2015SYE148 – 16-20 Pinnacle Street and 40-44 Pinnacle Street, Miranda

DA15/1254

## ASSESSMENT REPORT APPENDICES

**DRAFT CONDITIONS OF DEVELOPMENT CONSENT  
DEVELOPMENT APPLICATION No. DA15/1254**

**11 Basement 1 Plan - Deep Soil Area**

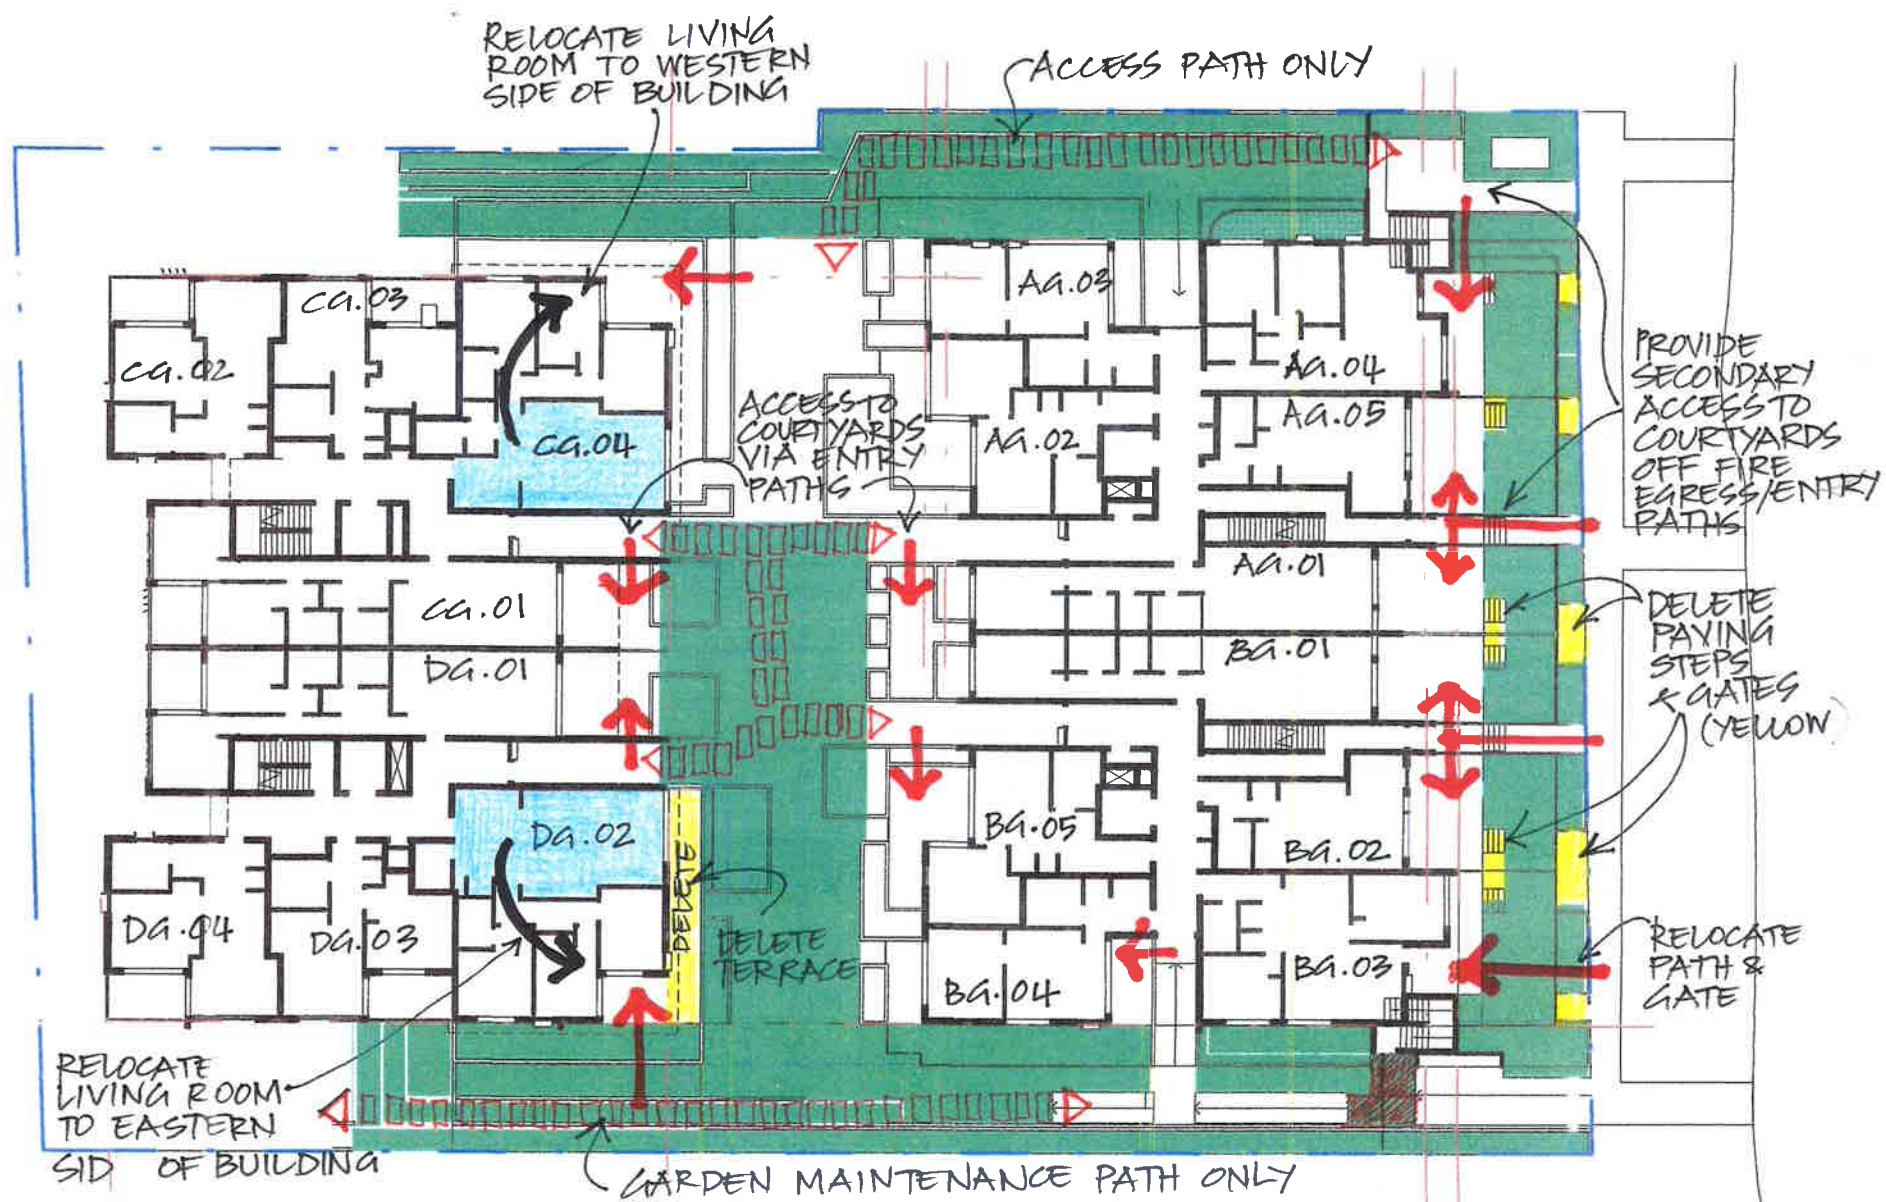
- ii) To increase the area of deep soil landscape:
  - To the north-facing ground floor Units AG.04, AG.05, AG.01, BG.01 and BG.02 delete the secondary access paths and gates. Provide direct access and gates to the courtyards of these units via the two entry paths and two fire egress paths. Relocate the secondary access to BG.03 to align with the living room.

- On the eastern side of the site delete all concrete stepping pavers except for a garden maintenance path connecting the pedestrian ramp and loading bay. Provide a larger area of Private Open Space on the eastern side of DG.02.

- In the central courtyard delete the timber deck along the northern side of Unit DG.02, the concrete paving adjacent to the courtyards of CG.01 and DG.01 and the secondary access paths and gates to the south-facing ground floor Units AG.01, BG.01, BG.04 and BG.05. Provide direct access and gates to the courtyards of these units via the entry paths or garden maintenance path.

- On the western side of the site delete all concrete stepping pavers except for the path leading to the central courtyard. Provide a larger area of Private Open Space on the western side of CG.04.
